# United Village

Appeal of Planning Commission Decisions  
Related to  
Hotel and Parking Garage Project

April 10, 2024 - City Council Meeting

Zoning File #24-022-766

# Variance #3 – Entrance Drive along University

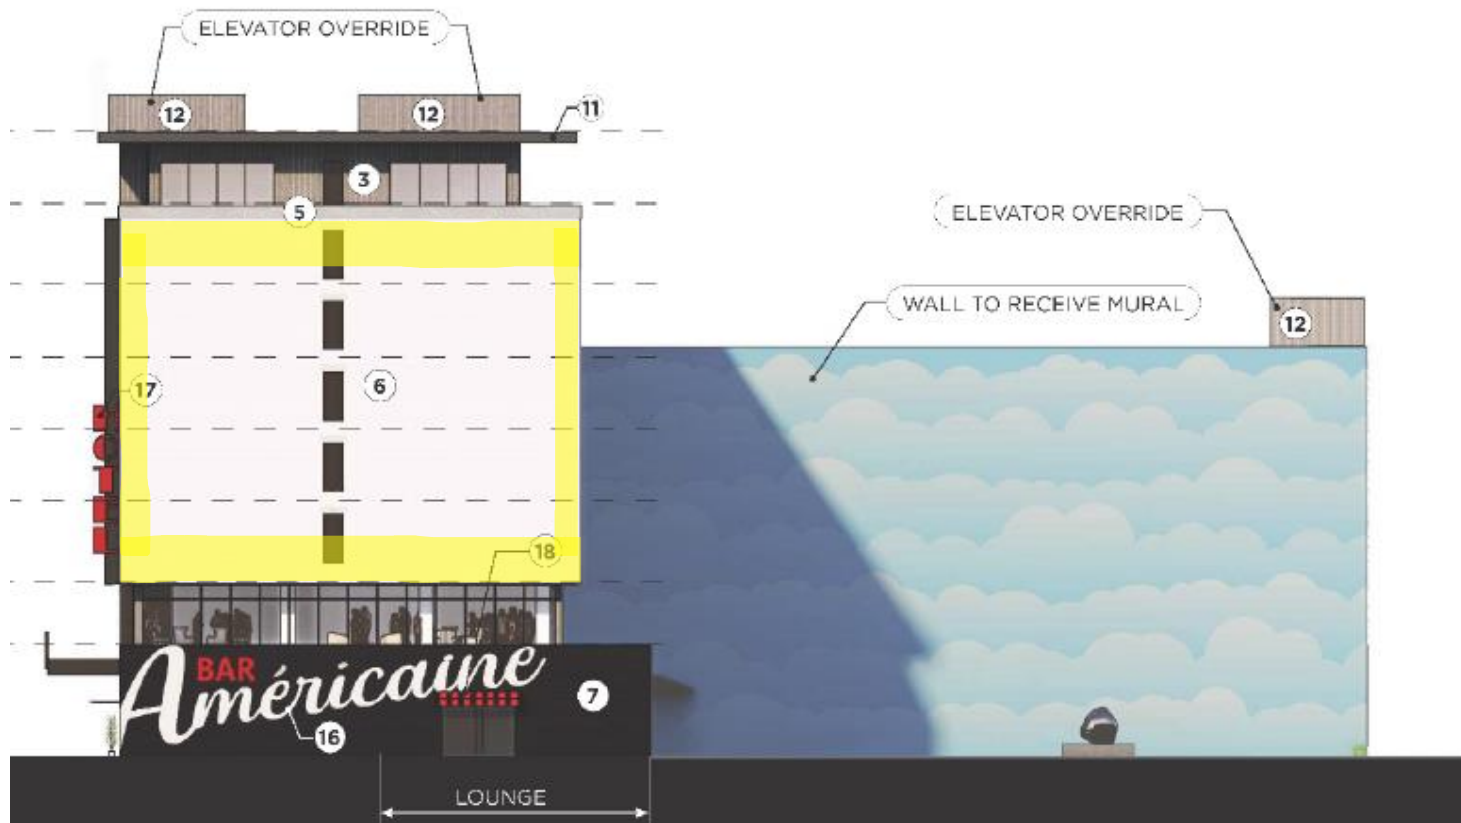
- Zoning Code limits driveway to 60' of lot frontage and 322' proposed for a variance of 262'
- Controlled access
- Utility boxes on University
- Side street access
- One-way westbound
- Drop-off/pick up lane
- Bypass lane
- No parking/No Not Enter Signs

- a) Entrance drive is vehicle-focused and does not provide safe and efficient circulation of all modes of transportation, including transit, pedestrian and bicycle traffic and is not in harmony with the Zoning Code.
- b) Entrance drive is contrary to comprehensive plan policies that call for: 1) focus on pedestrians, bicyclists, and transit; 2) high quality pedestrian urban design; 3) pedestrian-friendly streetscapes.
- c) Decision to site the driveway parallel to University Avenue is a choice made by the applicant and does not constitute a practical difficulty.

- a) Direct access from University is not allowed, the driveway is in harmony with the zoning code intent of ensuring convenience of access to property
- b) Comprehensive plan policies call for 1) minimizing and consolidating curb cuts and using side street access and 2) high-quality urban design that supports pedestrian friendliness and enhances the public realm
- c) Access management from county and city policies create practical difficulties as does presence of utility boxes along University

2. The United Village Final Plat shall be approved by the City Council and recorded with the county recorder and/or registrar of titles.
3. The driveway shall be for **one-way westbound** traffic only. Signage shall be installed indicating that **no parking** is permitted in the driveway and that the driveway is for check-in/check-out, pick-up/drop-off, and valet only. Signage shall indicate stopping in the bypass lane is prohibited.

4. The driveway shall be for **passenger vehicles** only as the site design cannot accommodate turning movements for larger vehicles.
5. There shall be a **direct pedestrian connection** between the sidewalk along University Avenue and the primary hotel entrance. The connection shall be reviewed and approved by Public Works.

6. There shall be a **landscape buffer** between the sidewalk along University Avenue and the driveway.
7. There shall be a **sidewalk width of 18'** along University Avenue.

8. The **owner/operator is solely responsible for ensuring the driveway operates in a safe manner for all users and does not result in adverse impacts to the public road system**. If the owner/operator is unable to manage the driveway in a safe manner that avoids adverse impacts to the public road system the City reserves the right to require closure of the driveway access points at the cost of the owner/operator. The owner/operator must at all times maintain an operating plan for the driveway and must provide it to the City upon request. This initial plan must be reviewed and approved by the Public Works Traffic Engineer during site plan review. Specifics to be addressed shall include: 1) document protocols, enforcement, and signage to limit the driveway to passenger vehicles, to manage the bypass lane, to prohibit parking and ultimately to assure no adverse impacts to the public road system; 2) quantify driveway use, frequency, volume, and peak times, etc.; 3) document how Metro Mobility, delivery vehicles, limousines, buses etc. will be accommodated and serve the site without adversely impacting the public road system.

# Variance #5 - West Wall of Hotel Portion of Building

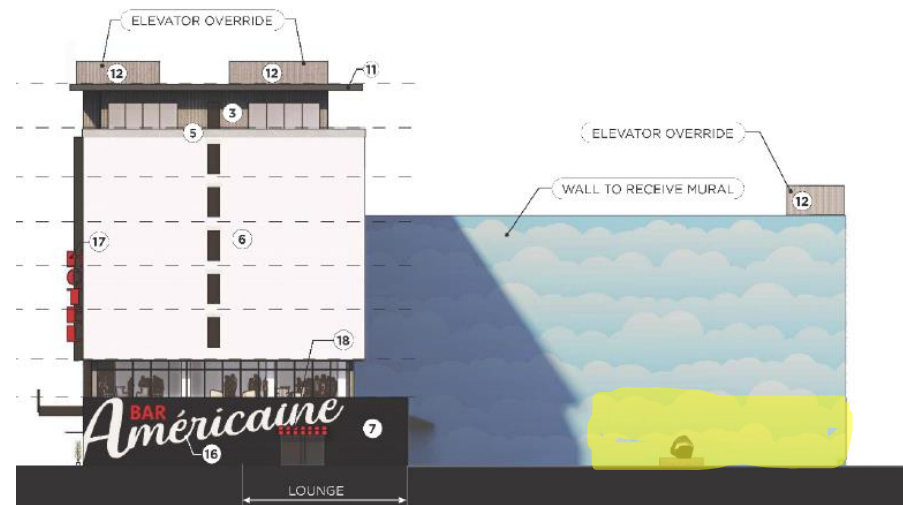
# Variance #5 Conditions – Windows on West Wall of Hotel

1. Final plans approved by the Zoning Administrator for this use shall be in substantial compliance with the plans submitted and approved as part of this application.
2. The United Village Final Plat shall be approved by the City Council and recorded with the county recorder and/or registrar of titles.
3. A wall graphic and lighting shall be installed on the west façade of the hotel portion of the building; this façade shall be lit at dusk.
4. A mural shall be installed on the west façade of the parking garage portion of the building within one year of the issuance of the certificate of occupancy. The mural shall be lit at dusk.
5. **Additional openings shall be added to the west façade of the hotel building on floors 3 through 7.**
